Access Compliance Report

Public Rights-of-Way

(Curb Ramps)

Intersection ID: 48147	Main Street: MCCAMEY_DR	Cross Street: FRANKLIN_MEADOWS_DR	Location: NW
ADA ID: 058041B5A4A1	Ramp Type: Perp	Initial Pass/Fail: Fail	Overall Compliance: No
			Severity Score: 13.75

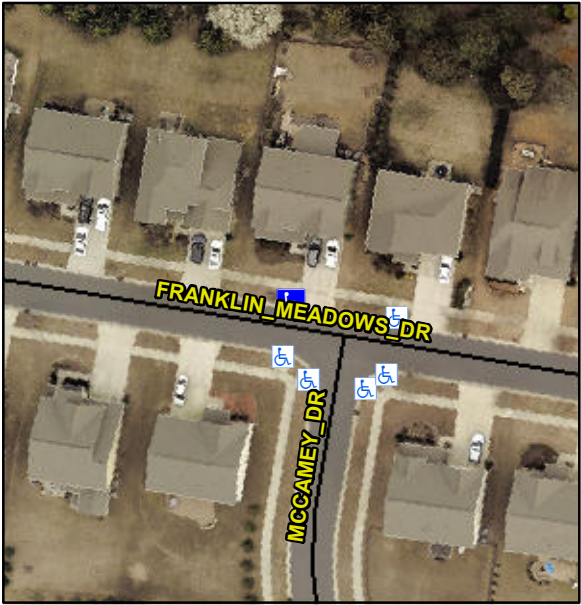
Codes/Mitigation Info/Possible Solution			Field Measurements/Component Compliance		
	Possible Solutions:		Compliance	Description	Data
	Remove & Replace Entire Ramp.		N/A	Ramp Length (in)	96.0
			Yes	Ramp Width (in)	60.0
			N/A	Flare Type LT	N/A
			N/A	Flare Slope LT (%)	N/A
			N/A	Flare Traversable LT?	N/A
			N/A	Landing Length (in)	N/A
			N/A	Landing Width (in)	N/A
			N/A	Landing Slope (%)	N/A
			N/A	Landing X Slope (%)	N/A
<p>Surveyor Notes:</p> <p>N/A</p> <p>PROW/ADA:</p> <p>R304.2.2, R304.5.3</p>			N/A	Flare Type RT	N/A
			N/A	Flare Slope RT (%)	N/A
			N/A	Flare Traversable RT?	N/A
			N/A	DWS Provided?	N/A
			N/A	DWS Contrast?	N/A
			N/A	DWS Length (in)	N/A
			N/A	DWS Full Width?	N/A
			N/A	DWS Offset (in)	N/A
			N/A	Shared Landing?	N/A
			N/A	Gutter Ponding?	N/A
			N/A	Gutter Lip Ht (in)	N/A
			N/A	Painted X Walk1?	No
				X Walk 1 Direction	To S
			N/A	X Walk 1 Width (in)	N/A
				X Walk 1 Slope (%)	4.3
				X Walk 1 X Slope (%)	1.2

N/A	Ramp inside XWalk1?	N/A
				Road Slope (%)	N/A
				Road X Slope (%)	N/A
			N/A	Any Obstructions?	N/A
				Obstruction Type	
Total Cost:		\$ 1850.00			
			N/A		N/A
			Yes	Surface Condition? (G/P)	Good
